**BEFORE THE PUBLIC UTILITY COMMISSION
OF OREGON**

LC 73

2019 Integrated Resource Plan

THE RENEWABLE ENERGY
COALITION'S COMMENTS ON THE
IRP UPDATE

Figure 1. Solar ELCC Comparison

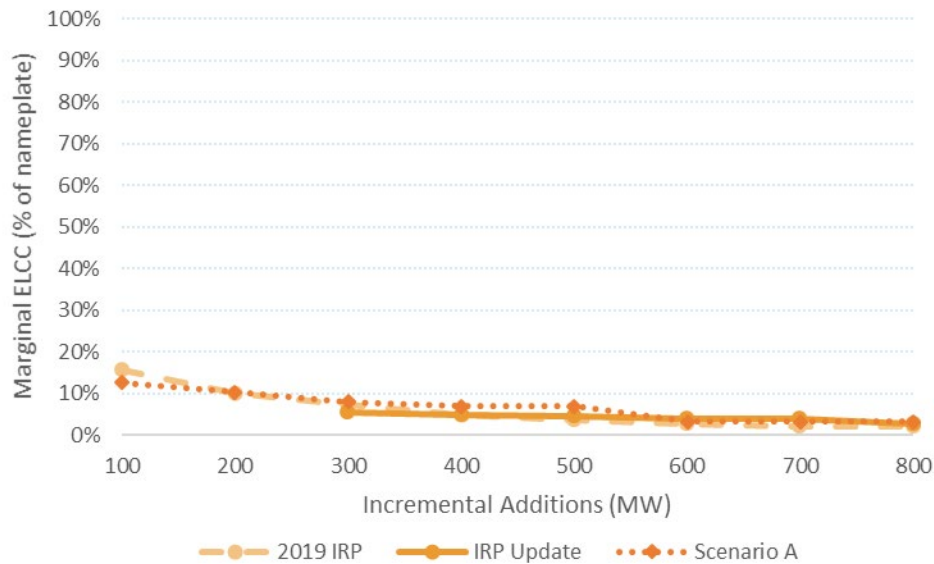
In order to provide some additional insight into the impact of the additional solar resources in the Baseline Portfolio, PGE prepared analysis examining a scenario based on the 2019 IRP Update Sequoia model with 200 MW of solar resources removed from the Baseline Portfolio to approximate the quantity of solar in the 2019 IRP study. **Figure 1** compares the ELCC values for solar from the 2019 IRP and the IRP Update with the scenario (labeled Scenario A in the figure).⁴ The figure aligns the ELCC values based on the approximate quantity of solar resources in each study. The scenario showed a similar pattern to the 2019 IRP, with a higher initial ELCC value for solar than the IRP Update (as expected due to a reduction of solar in the portfolio compared to the IRP Update), and a declining value for the next increments. There was little change to the ELCC values for Gorge Wind and the SCCT compared to the IRP Update (26% and 95.2% in Scenario A compared to 25% and 95.5% in the IRP Update).

As discussed previously, the capacity need reporting convention in the IRP Update (and Scenario A in Figure 1) differs from the 2019 IRP. It is important to note that when converting capacity contribution MW values to \$/kW-yr values, the net cost of capacity should be based on the same reporting convention as the ELCC values.
